PUBLIC NOTICE EXETER CONSERVATION COMMISSION

1. Review of a Wetland Waiver and Shoreland CUP from Palmer & Sicard Inc., for a 26,989 SF Office/Warehouse on Holland Way (Tax Map 66-1, Planning Board Case 18-22) (*Luke Hurley, GES Inc., Christian Smith, Beals Assoc.*)

Re: Site Plan Review TRC Comments
PB Case #18-22
Tax Map Parcel #66-1

REVISED PER ENG. REVIEW	2-20-19
REVISIONS:	DATE:
EXISTING CONDITIONS	
PLAN FOR: COMMERCIAL DEVELOPMENT HOLLAND WAY EXETER, NH	
DATE: DEC. 2018	SCALE: 1"=80'
PROJ. NO: NH-236.52	SHEET NO. 1 OF 9

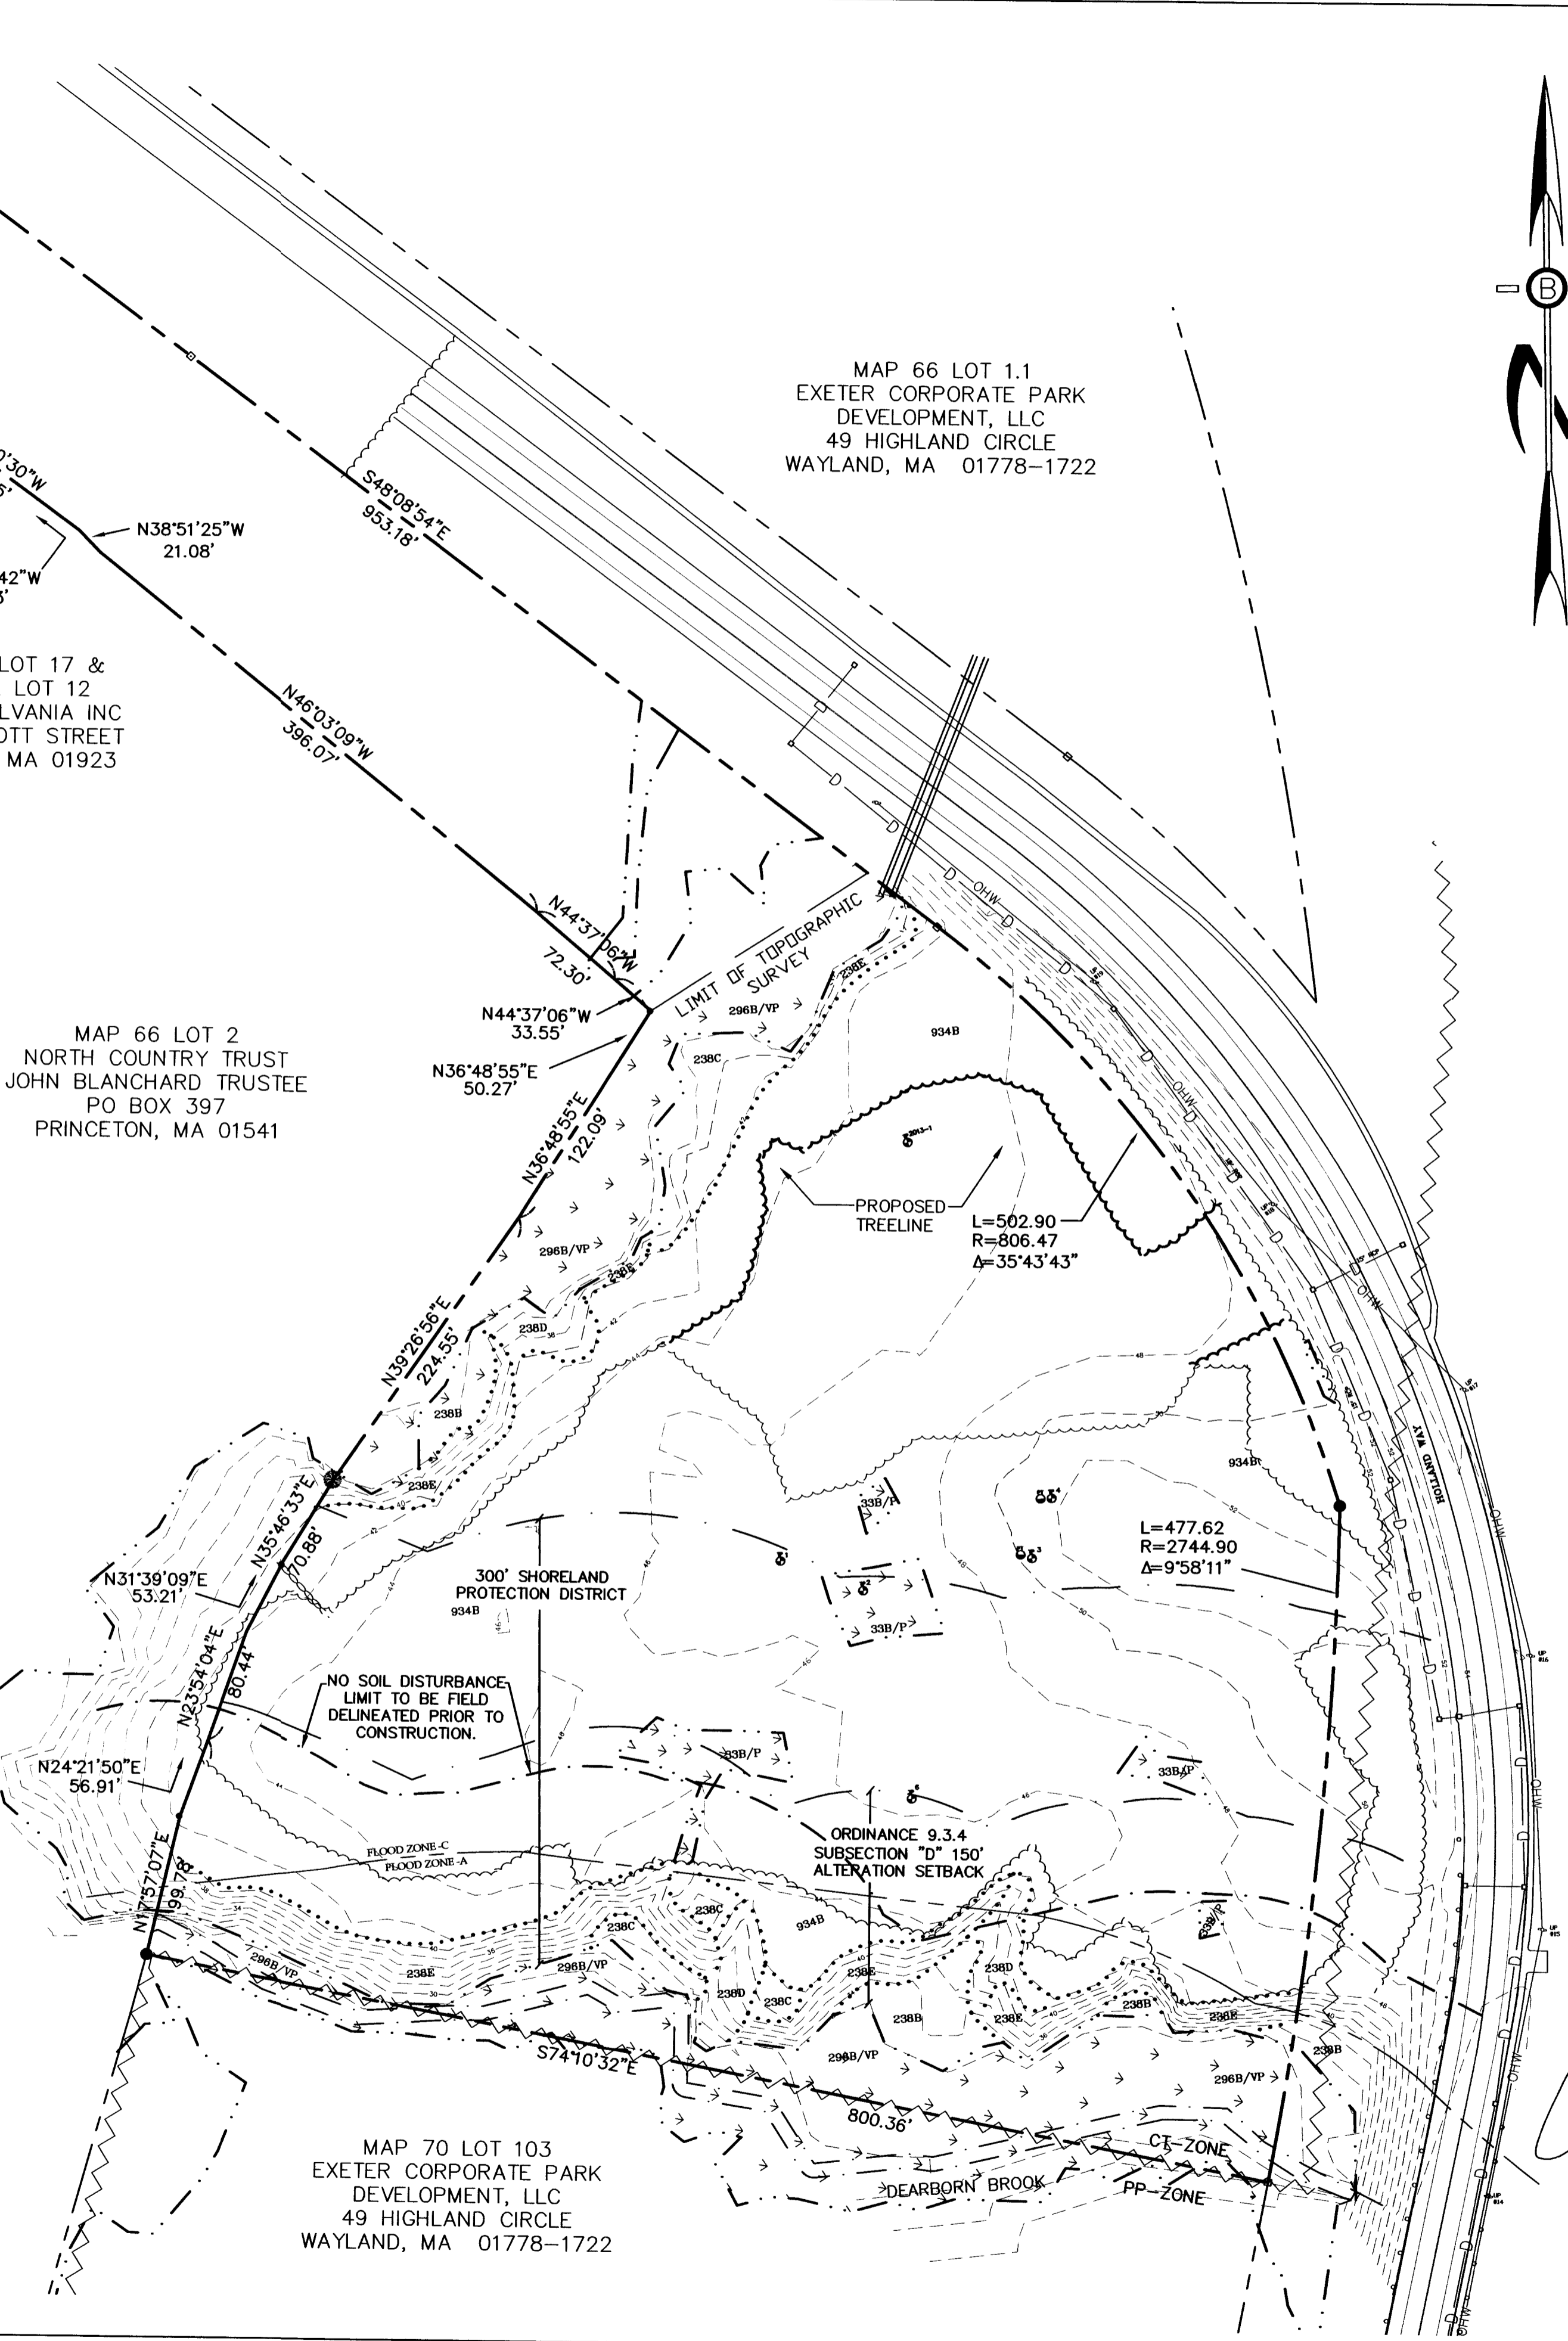
3. Significant trees not identified per 7.4.7; **Response: Waiver request submitted.**
4. High Intensity Soil Survey not provided per 7.4.10; **Response: Shown on sheet 1, line types have been edited for clarity.**

6. Show "Flood Hazard Zone", referenced in Note 3 on Sheet 1, on Sheet 2; **Response: This is shown on the plans (see sheet 1).**
7. Explain landscaping in Shoreland district; **Response: This was from the previous site plan approval and has been removed.**

REVISED PER ENG. REVIEW	2-20-19
REVISIONS:	DATE:
PARKING/PAVEMENT PLAN	
PLAN FOR: COMMERCIAL DEVELOPMENT HOLLAND WAY EXETER, NH	
DATE: DEC. 2018	SCALE: 1"=30'
PROJ. NO: NH-236.52	SHEET NO. 2 OF 9

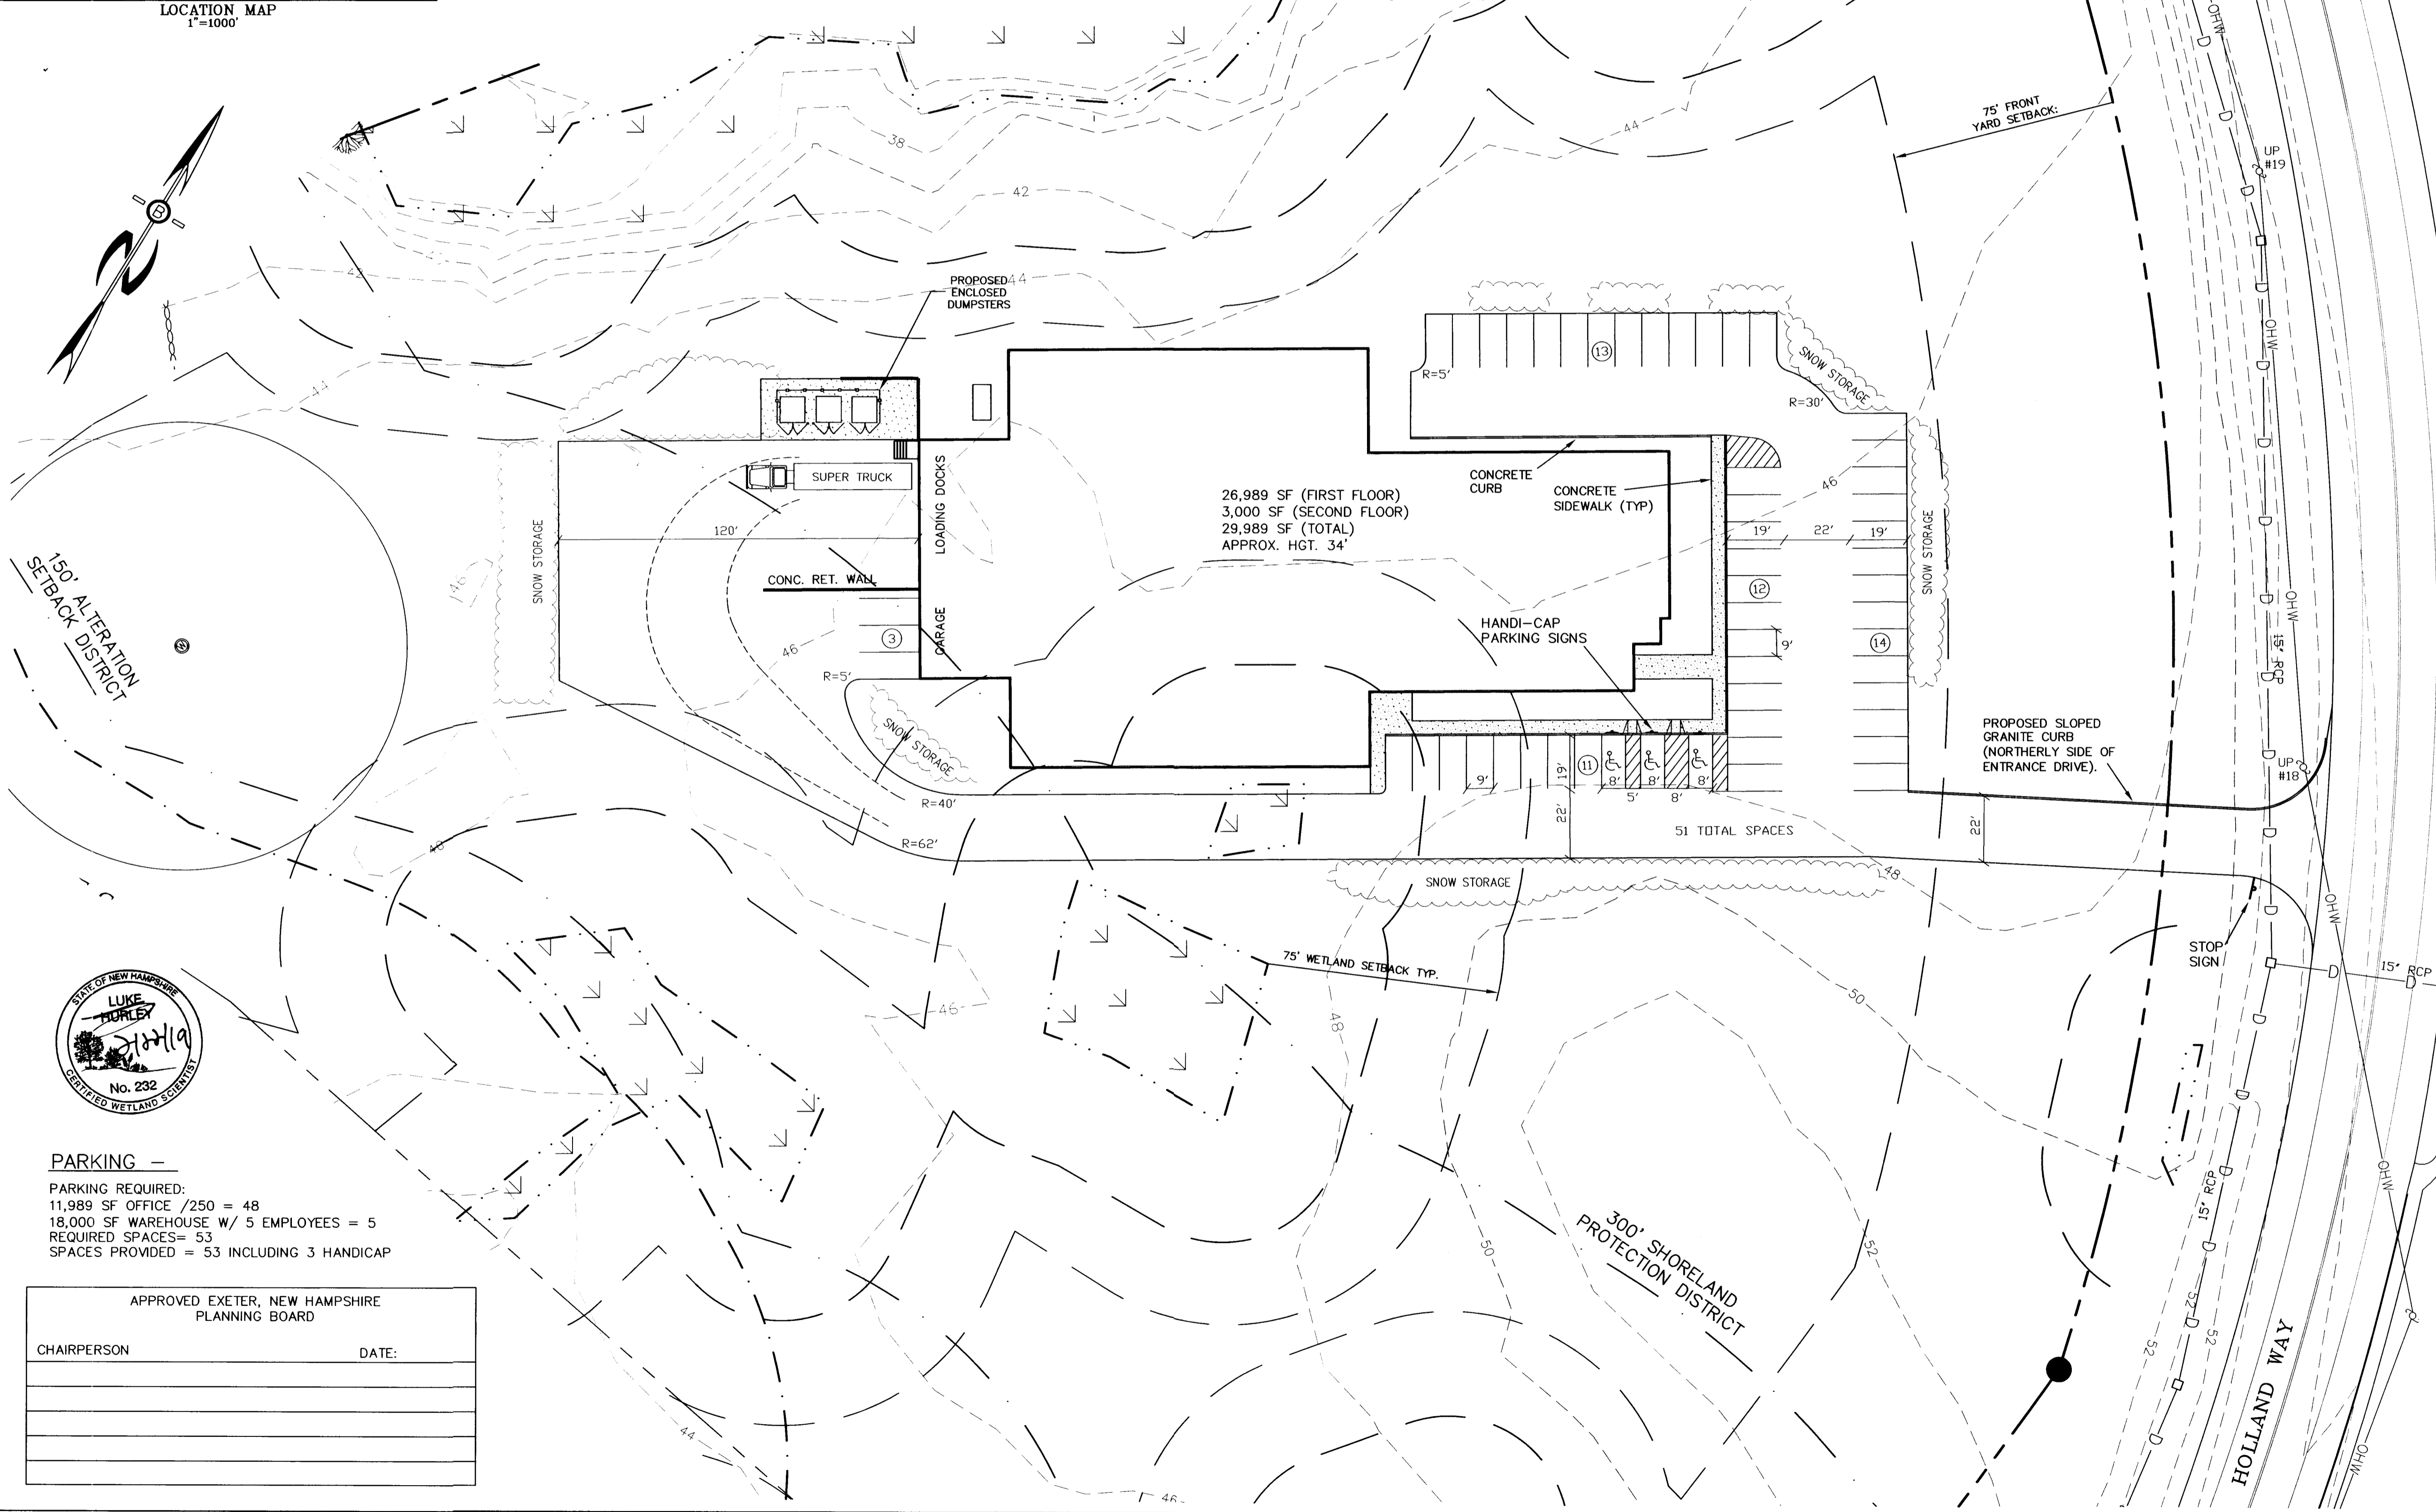
4. Sheet 2 of 9 Parking and Pavement Plan
 - a. A waiver is required for bituminous curb along the driveway. Granite curb is required within the ROW. **Response: The curbing has been revised to granite.**

- b. Show the proposed well and protective radius. Snow storage is not allowed within the protective radius. Signage is recommended in this area to prevent snow storage. **Response: The well has been relocation further away from the building and away from any possible snow storage.**
